RESPONSE TO STAFF COMMENTS

TO: Hingham Conservation Commission

RE: 18 Shipyard Drive, Hingham

Please include this Response to Staff Comments with the Notice of Intent (NOI) application under review for the proposed patio project at 18 Shipyard Drive in Hingham (the Site). This submittal responds to the 4/28/26 email with comments as noted below with our response following in italic:

A1.01

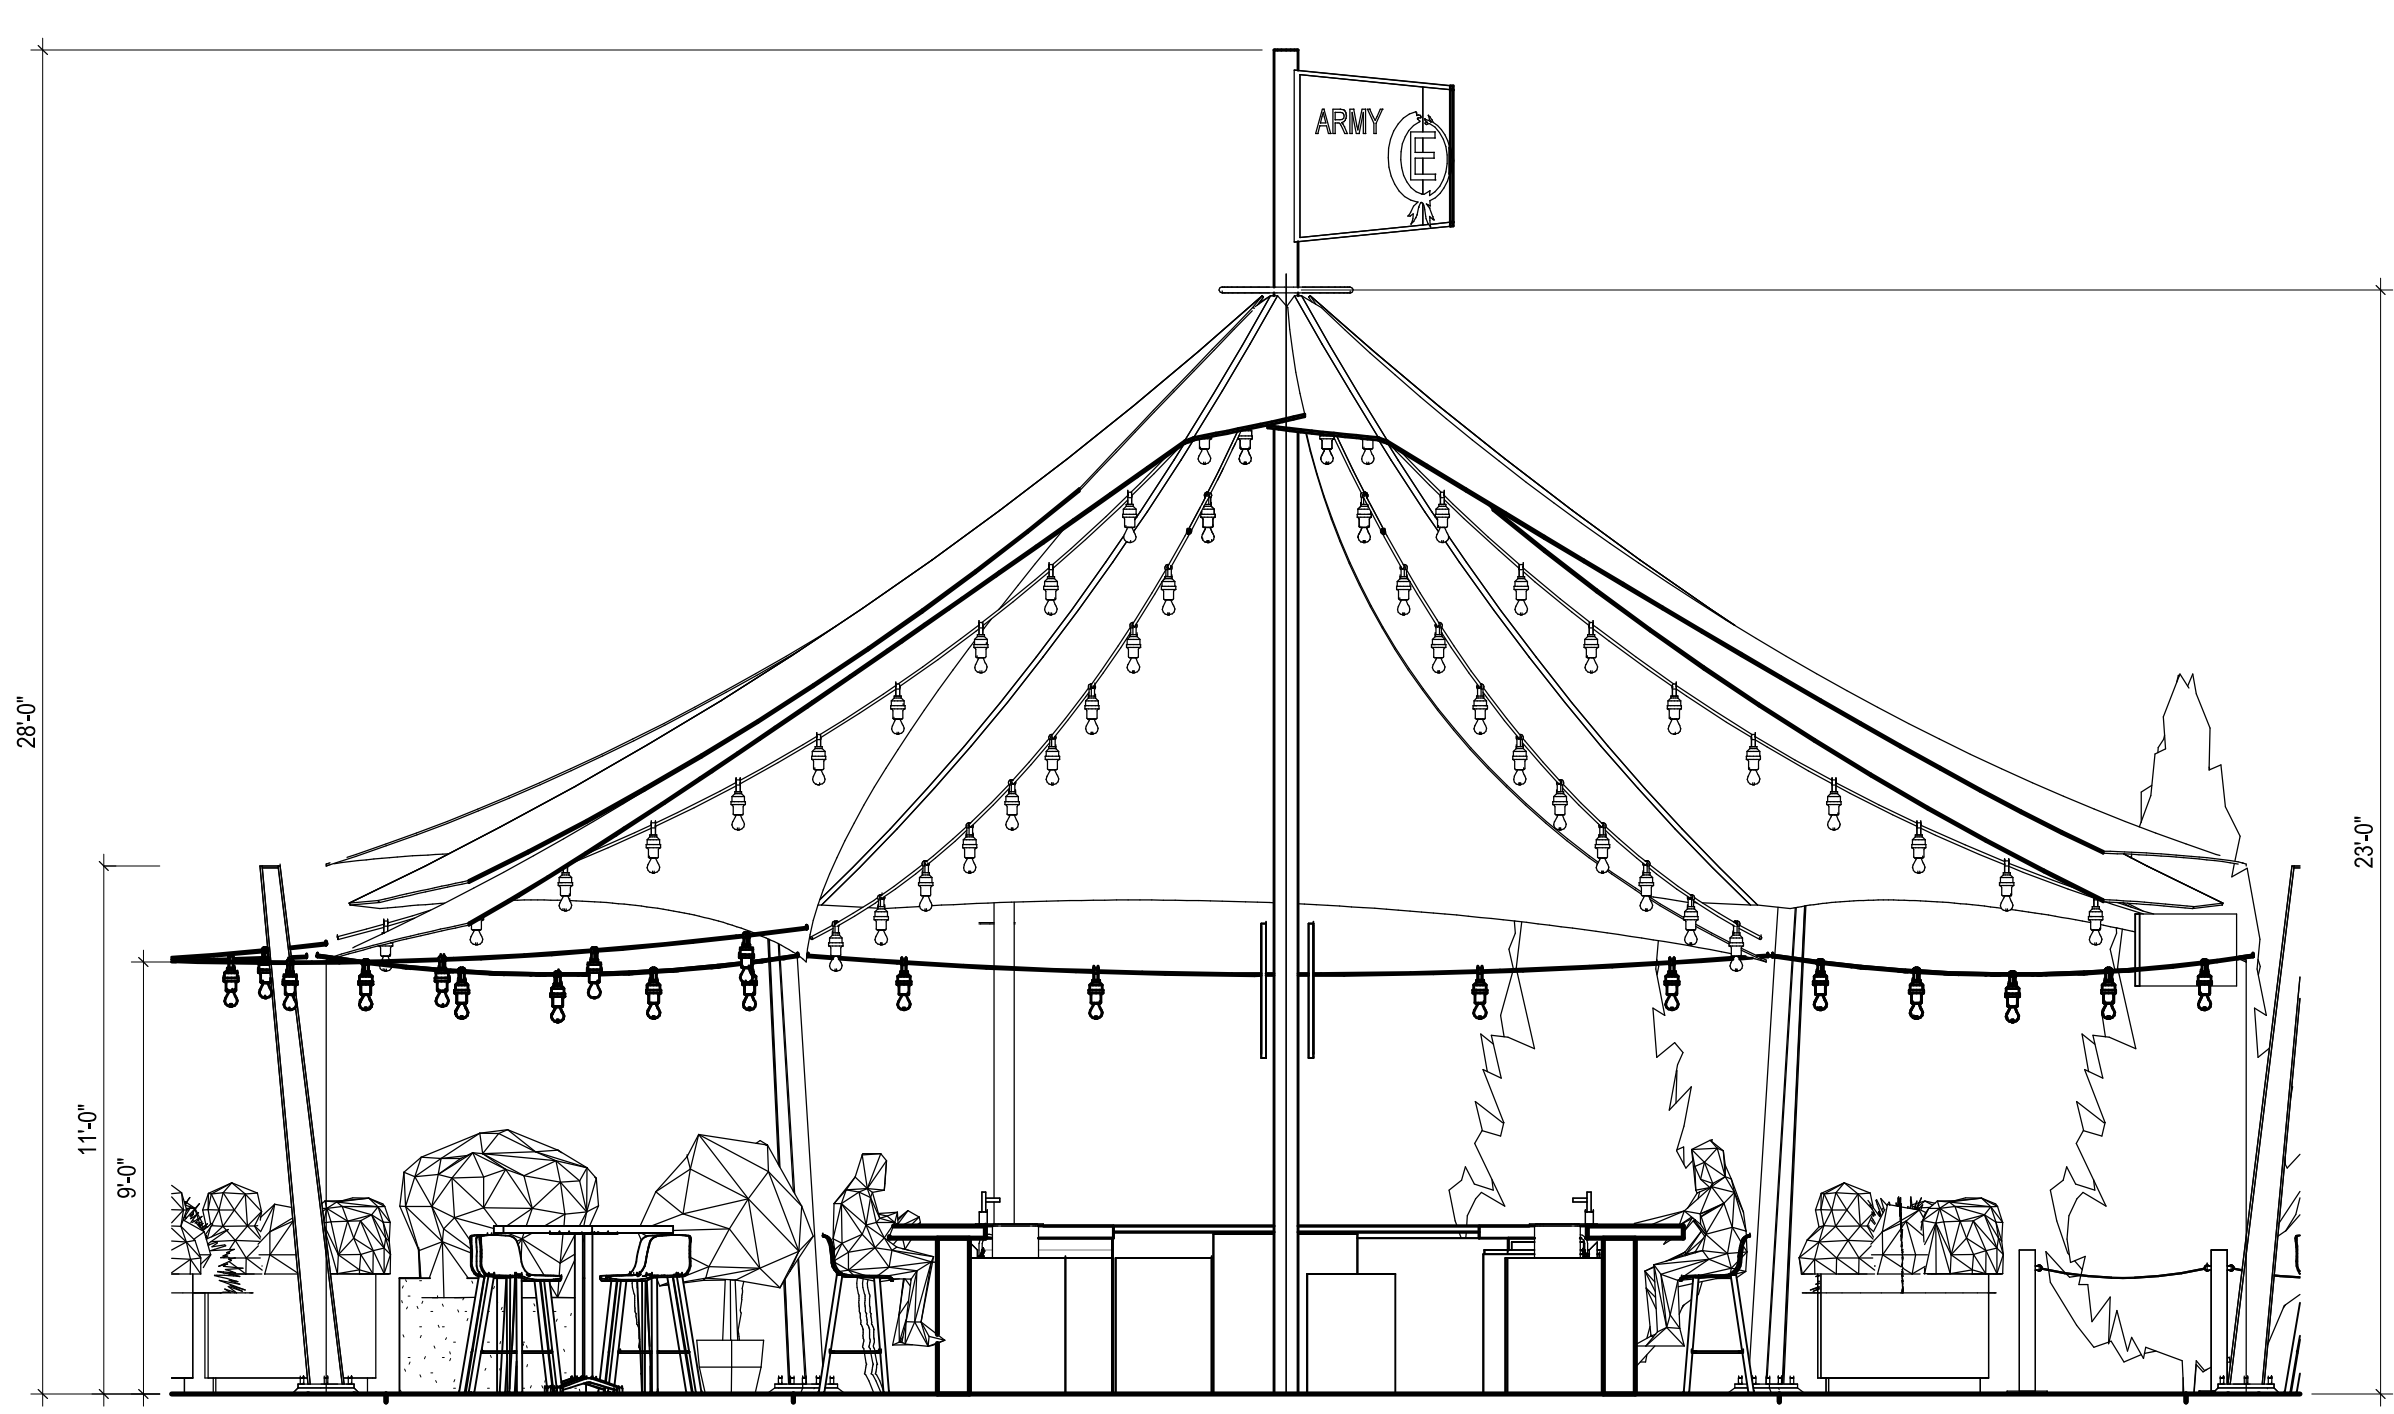
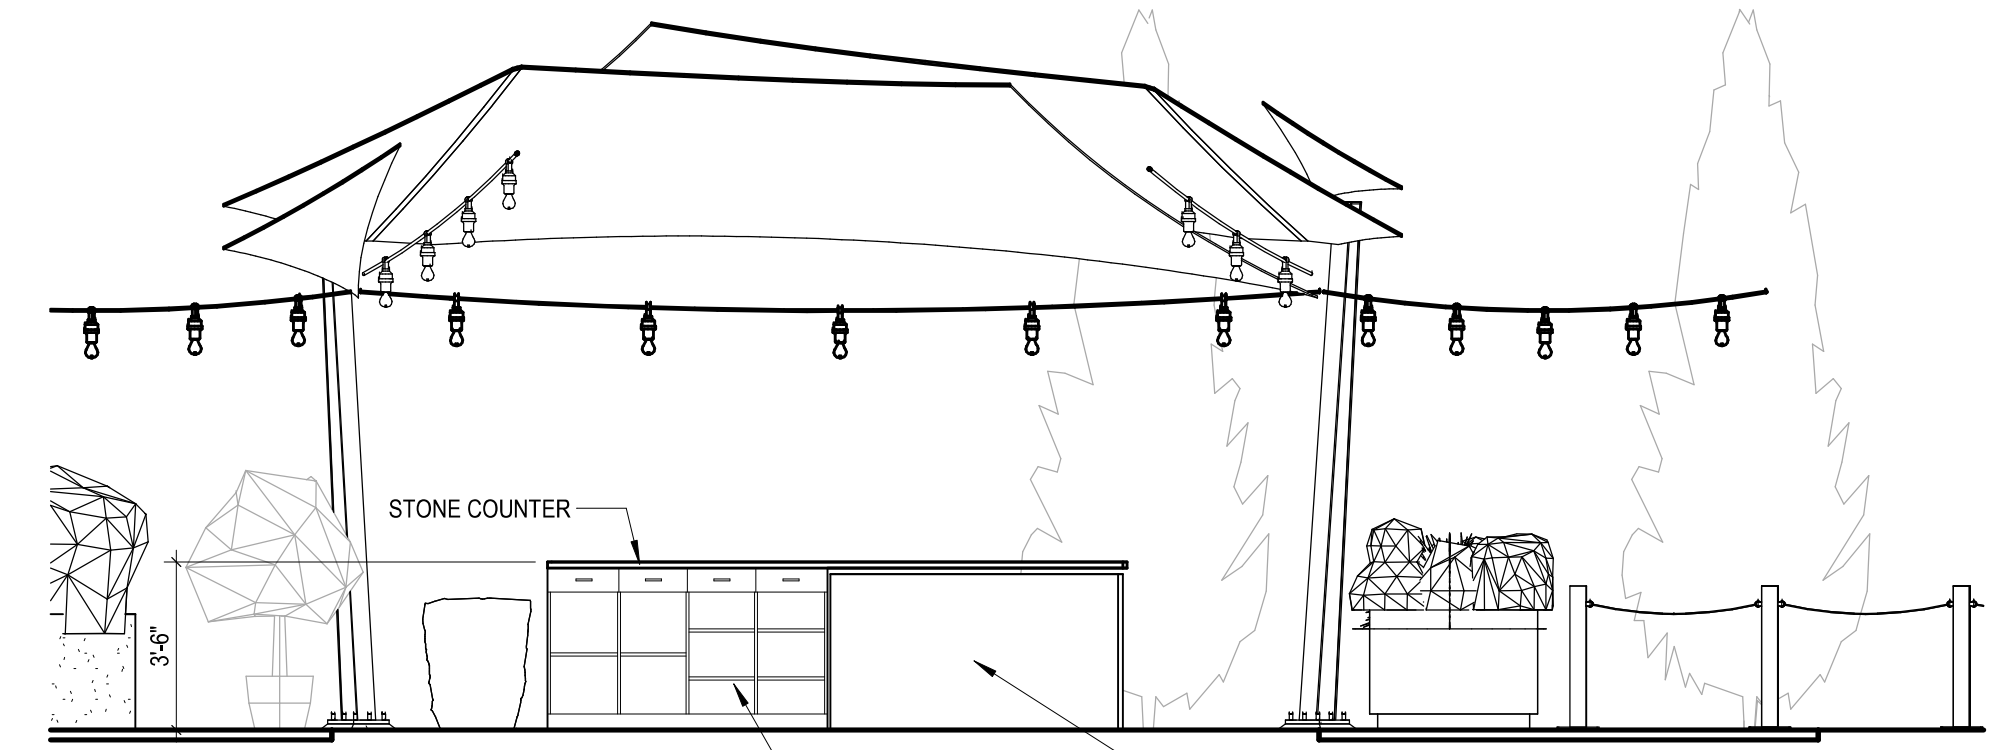
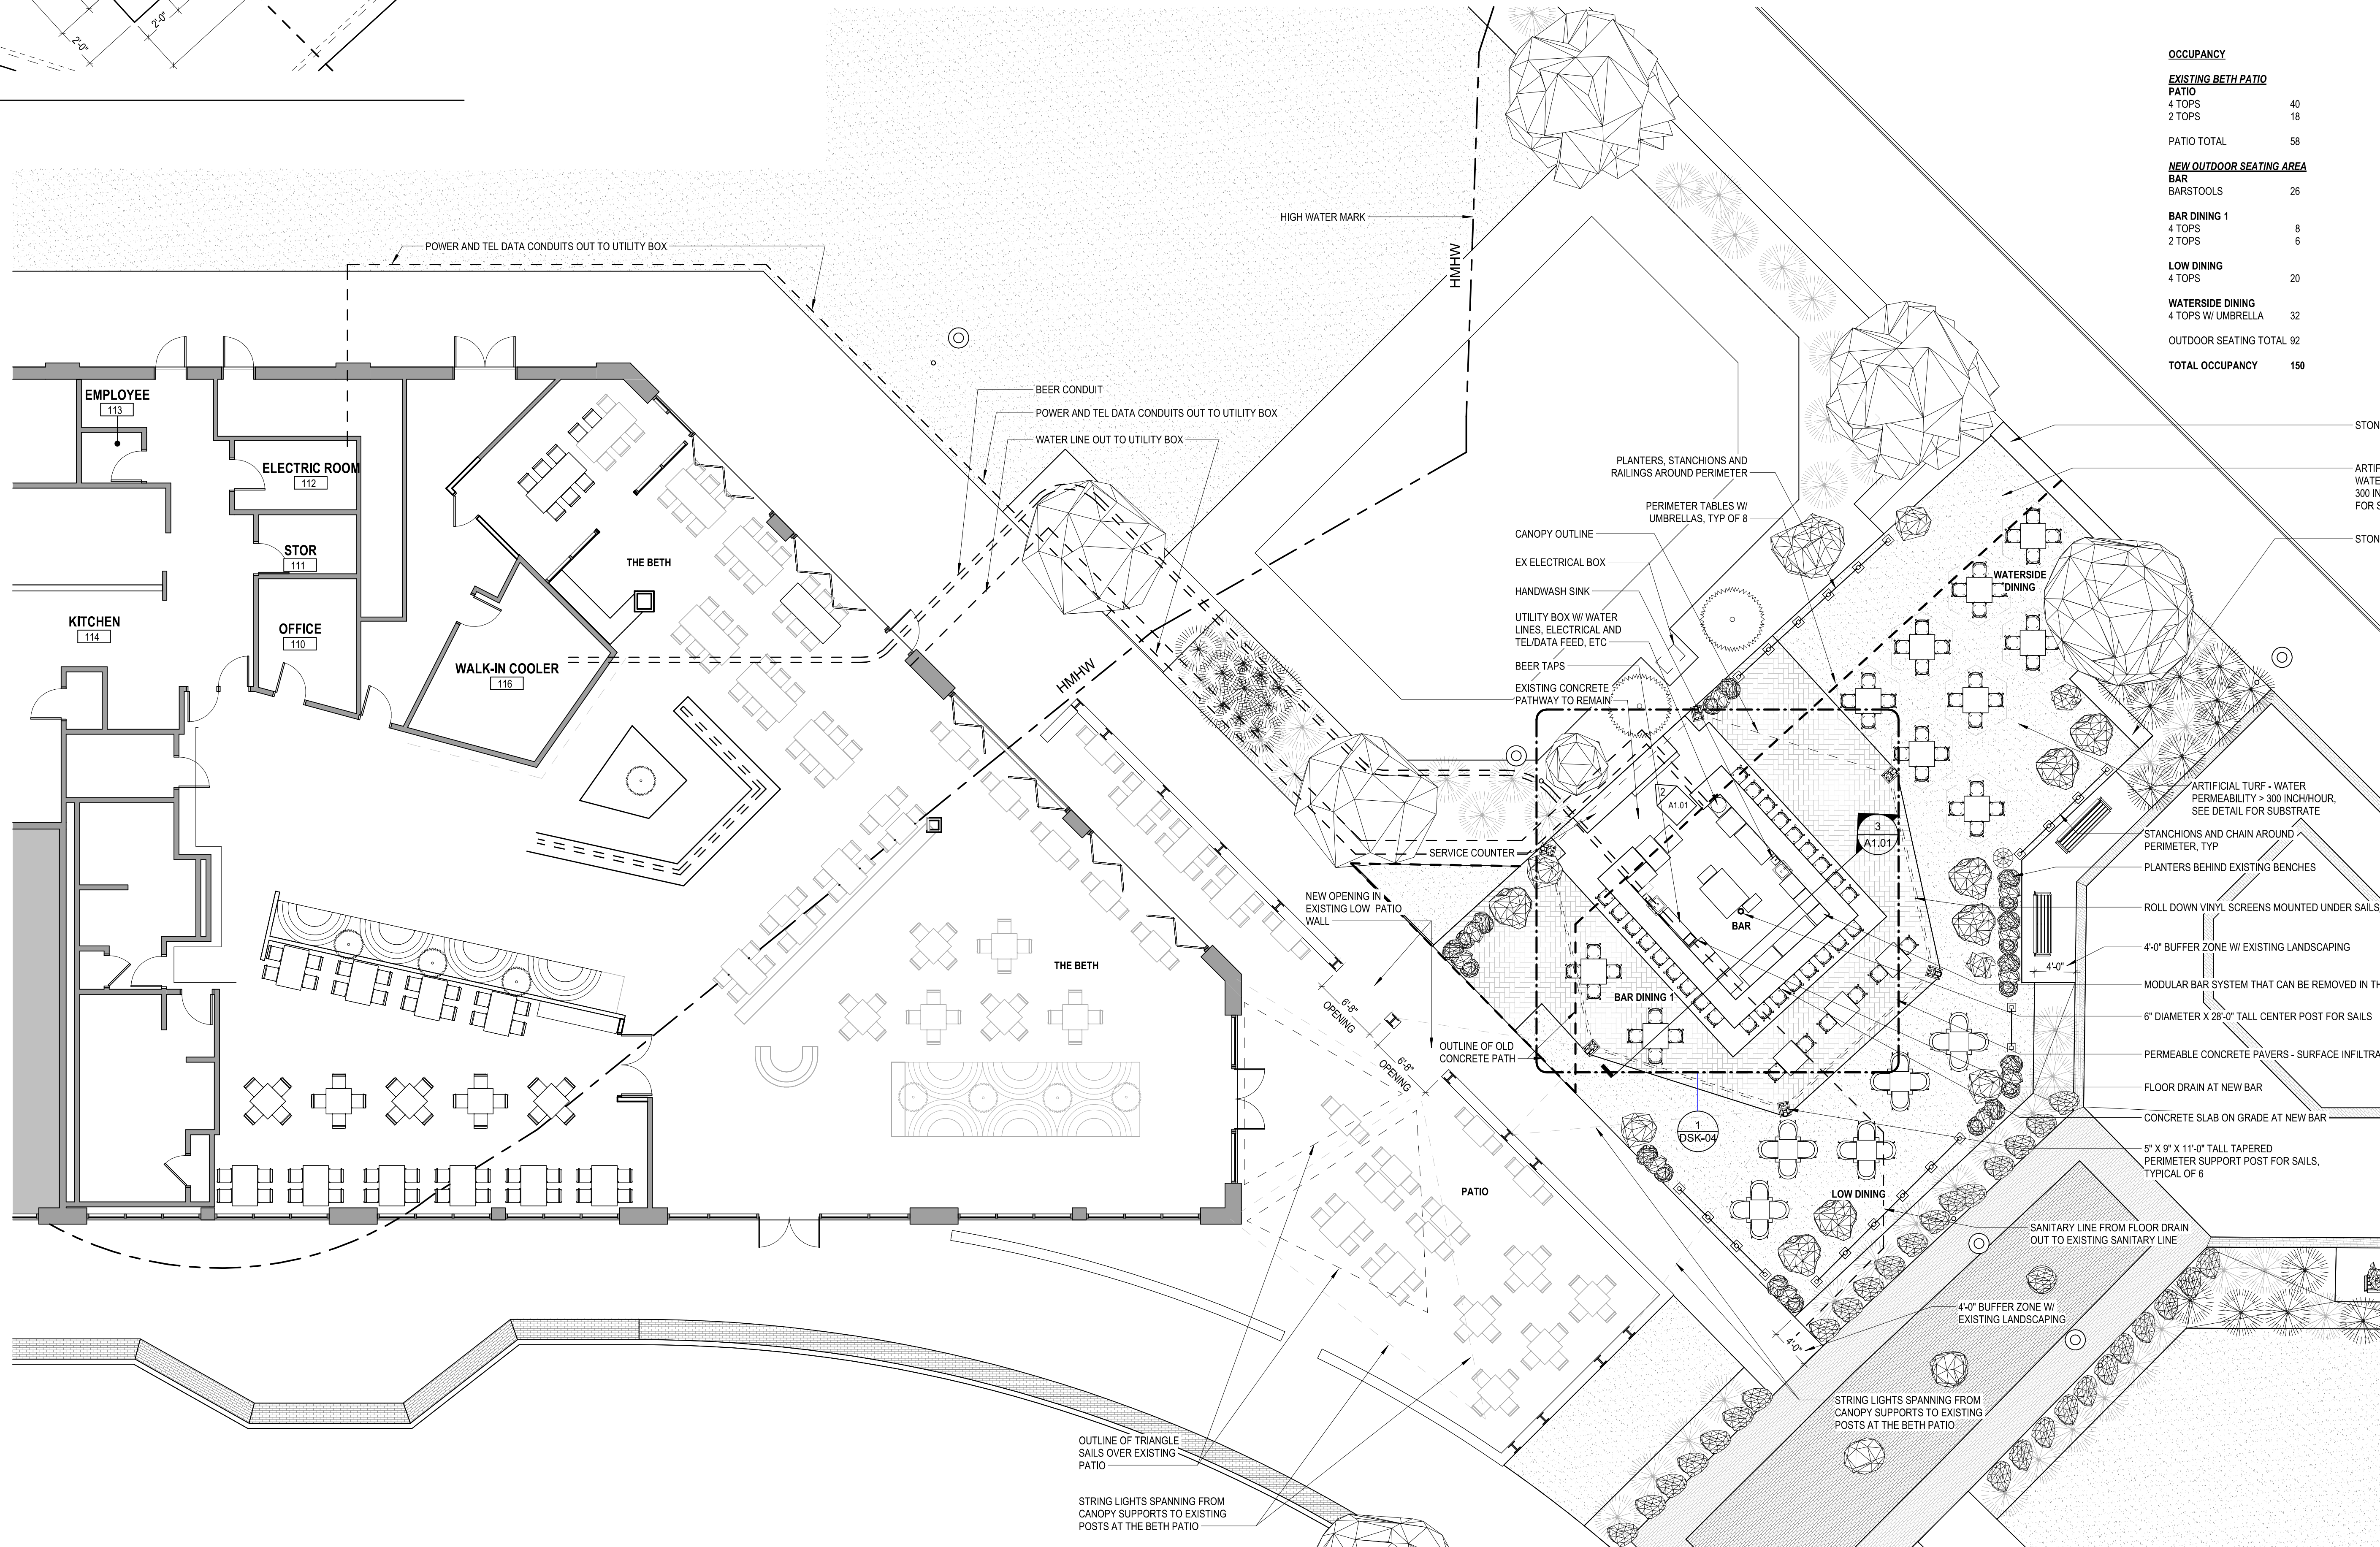
- The project description does not appear to include all aspects of the proposal. Please expand on the proposed pervious patio details and describe any other proposed work in jurisdictional areas

(retaining wall, canopy, bar, etc.) which are apparent on plans uploaded to the town's Permit Eyes (application #65618).

- The plans uploaded to Permit Eyes are prepared by DEFY Architecture and depict a different patio layout and landscaping and include additional details not shown on the plans submitted to Conservation including use of artificial turf. The project description in the NOI narrative refers to “environmentally friendly lawn” and native plant species. Please clarify and include specifications for turf, if proposed. Please note, plans submitted to multiple departments should be consistent to avoid delays with review and permitting. Staff recommends the stamped architectural plans be submitted with the NOI for review by the Commission.

Response –Included in this response submittal are the stamped architectural plans, sheets A1.01 Proposed First Floor Plan, Section and Interior Elevations and A2.01 Reflected Ceiling Plan & Details that include all aspects of the proposed patio project and is what was used as the basis for the exhibit plans submitted as part of this NOI. The NOI Narrative has been updated to reflect the full scope of patio project. Please note that the building permit application #65618 includes outdated plans, which will be corrected to match the stamped architectural plans referenced above.

Response – The building permit application #65618 includes outdated plans, which will be corrected to match the stamped architectural plans referenced above. The NOI Narrative has been revised to reflect the full scope of the patio project. The stamped architectural plans are included in this submittal and are now consistent with the engineering plans that are included as exhibits to this NOI. Please see the last comment response that's specific to the submitted NOI plans and revisions to those plans.
